FONTHILL STATION WESTSIDE  
ENTRANCE STRUCTURE EXTRACT

Extract No. S005/001  
EXTRACT FROM RWO STRUCTURE PLAN No. S005

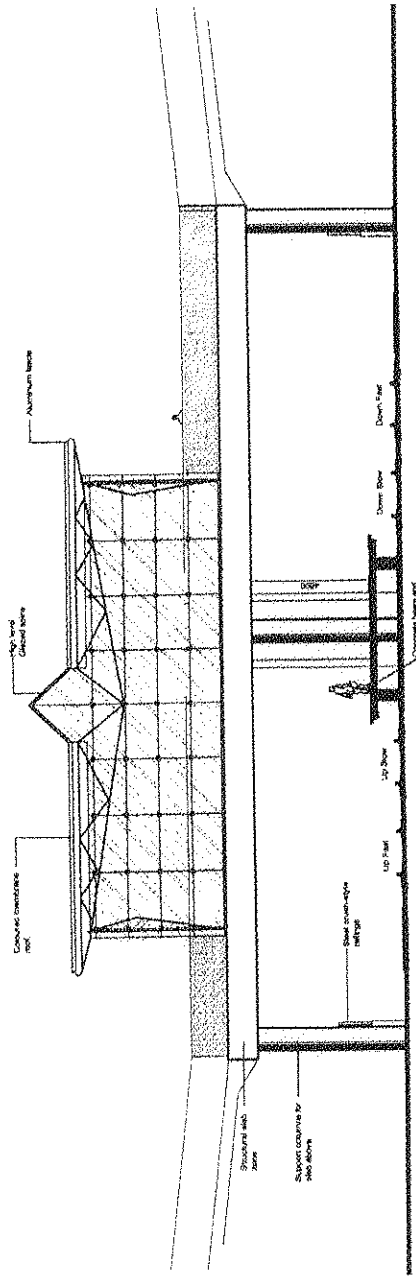
This extract shows the physical changes to the KRP RO scheme. All additional permanent and temporary landtakes required as a result of the physical changes have been agreed between CIE and the relevant landowners.
